STAFF RECOMMENDATION

NCPC File No. 6614

WASHINGTON NATIONALS BASEBALL STADIUM

May 25, 2006

Fig 5 Perimeter Security

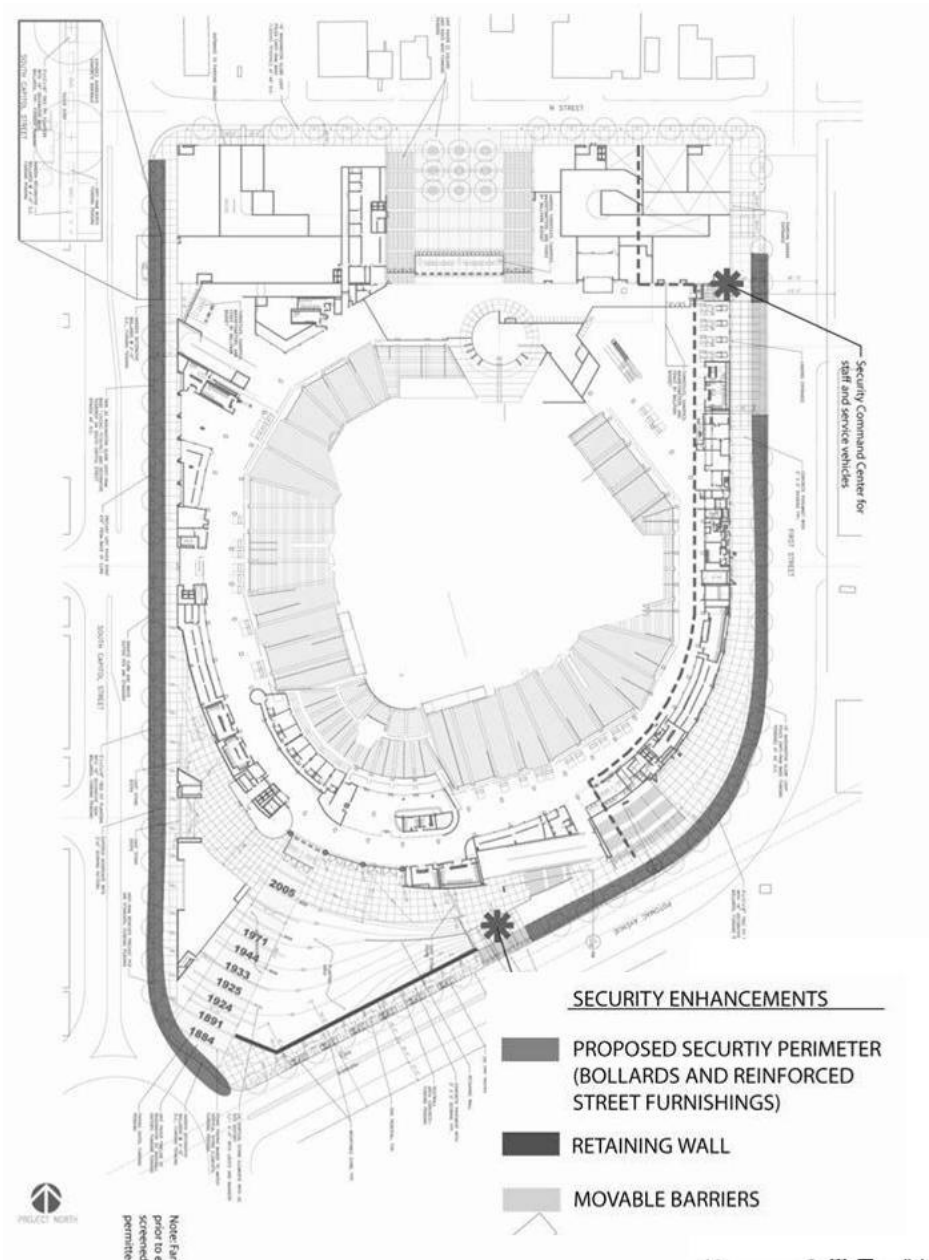
The applicant has performed a risk assessment and has noted the intention to provide perimeter security in accordance with the National Capital Urban Design and Security Plan. However, the submission does not provide detail design and specifications of the elements or include supporting documentation to evaluate primary objectives. Furthermore, the Urban Design and Security Plan does not include a design framework for perimeter security along South Capitol Street. **Staff recommends that further information be provided regarding the justification for and design of perimeter security elements.**

Fig 16 **Base Plan and Opt 1 & 2 Preferred Uses – Main Concourse Level**

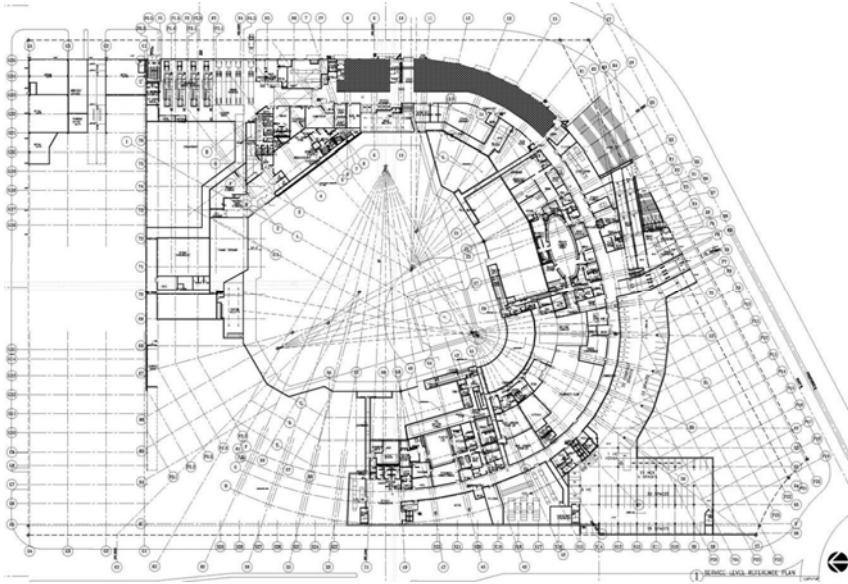
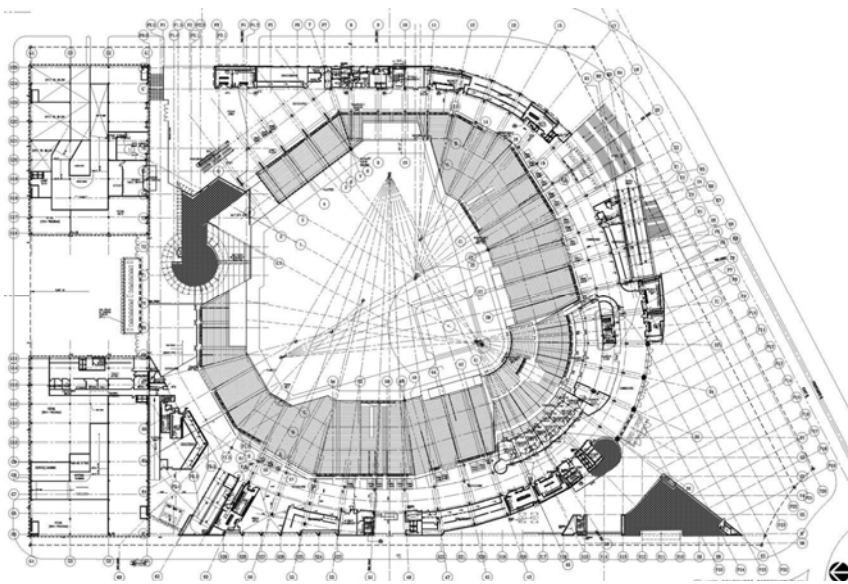
Staff supports the Zoning Commission's requirement that "not less than twenty percent of the Ballpark building's exterior perimeter frontage... be devoted to retail, service, entertainment, or arts uses (preferred uses)..." A variety of preferred uses should be maximized to the greatest extent possible around the entire site in order to promote and sustain active street life during game days and especially during non-game days. The Base Plan will provide approximately 10 percent of the perimeter for preferred uses however, for the most part, they will be Ballpark functions, such as ticket booths, team store and baseball offices which will support minimal non-game day activity. The proposed center field restaurant will be located internally to the Ballpark and not be seen from the perimeter. The nine consecutive service bays and wide driveway apron along First Street will not promote pedestrian activity and denote the back-of-house. Options 1 and 2 will exceed the 20 percent minimum for preferred uses and will invigorate and promote street activity on First Street during game days and non-game days. However, the ground level of the proposed administration building provides the largest preferred use on South Capitol Street in the Base Plan or in Options 1 and 2. **Staff does not support providing the applicant with relief from current zoning requirements for preferred uses and recommends that additional preferred uses be located along South Capitol Street in order to activate and support street life during non-game days. Further information on uses and building façade articulation along South Capitol Street should be submitted.**

Fig 21 Sports Lighting

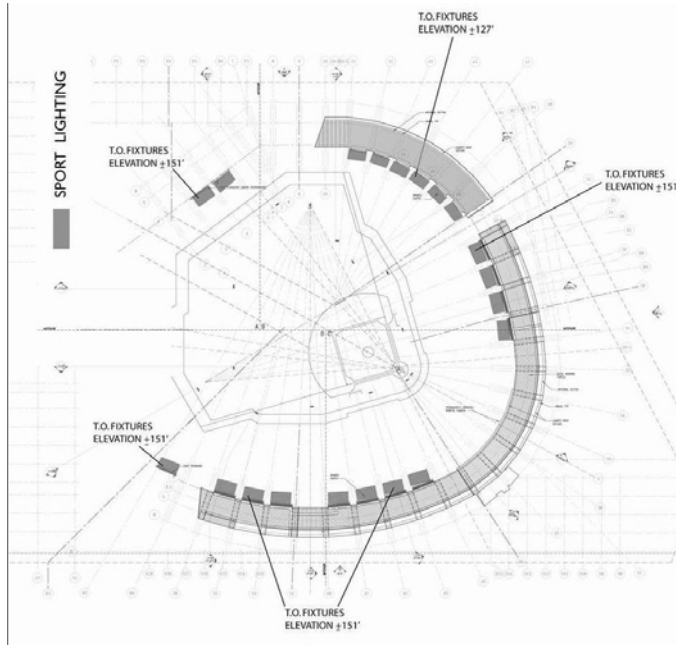
The submission did not include any design and specifications for the general illumination of the ballpark exterior. The applicant has noted that the proposed ballpark building mass will help minimize the light spill from sports lighting; however, light will emanate towards the north and east of the site where the ballpark massing is lower. Staff notes that the height of future development around the ballpark site may minimize the light spill in this area. **Staff recommends that the applicant submit further information, including photo simulations and footcandle modeling for exterior illumination of the ballpark and sports lighting, so that the Commission can evaluate the impact of lighting upon nighttime vistas and viewsheds to and from the Capitol and the Anacostia River.**

Fig 20 Signage

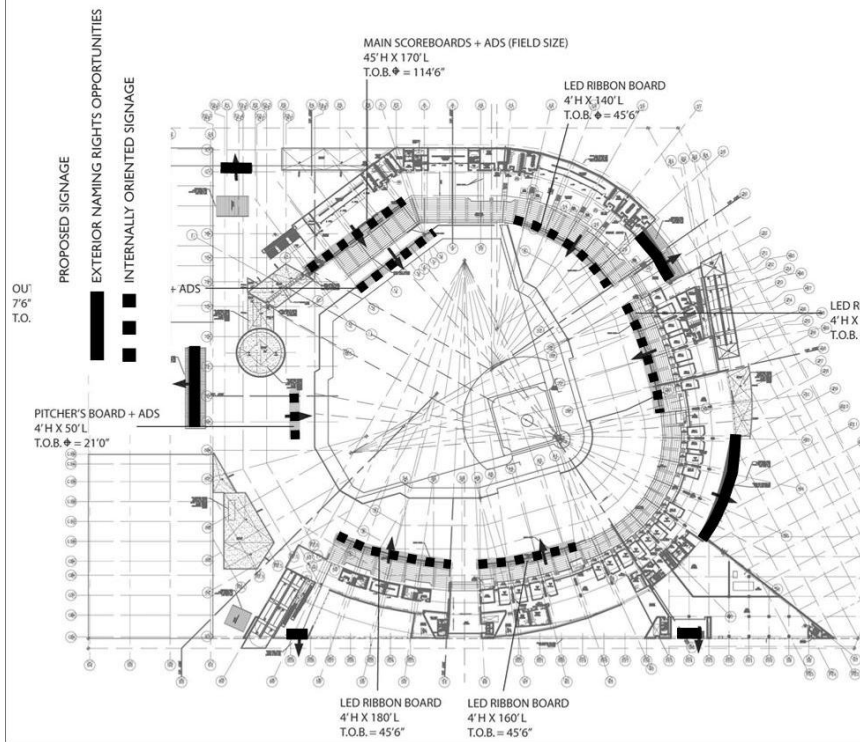
The location and design of the proposed monumental naming rights sign, that will be located on the curving upper concourse façade facing south to Potomac Avenue, will have significant impacts upon the skyline and vistas of the Capitol and monumental core from the Frederick Douglas Bridge, the South Capitol Street gateway, the Anacostia River, the Anacostia ridgeline, Interstate 295 and federal installations and neighborhoods located on the eastern side of the Anacostia River. The submission did not include any design and specifications for any other exterior signage surrounding the ballpark. **Staff recommends that the applicant submit the design and specifications of the proposed monumental naming rights sign and all other illuminated exterior signage, in particular those that will be located adjacent to public entries, in order to evaluate their impacts upon vistas and viewsheds to the Capitol, monumental core and areas immediately surrounding the Ballpark site.**

The applicant did not include the design of the scoreboard, both front and back, with the submission. The proposed scoreboard will not be seen from certain exterior locations with higher building massing, such as the curved upper deck and upper concourse building. However the scoreboard will be seen from various visual penetration points through the ballpark as well as from the north and east of the site where the ballpark massing is lower. Staff notes that the height of future development around the ballpark may diminish these views. **Staff recommends that the applicant submit the scoreboard design in order to evaluate its visual impact upon vistas and viewsheds as well as from areas immediately surrounding the Ballpark site.**
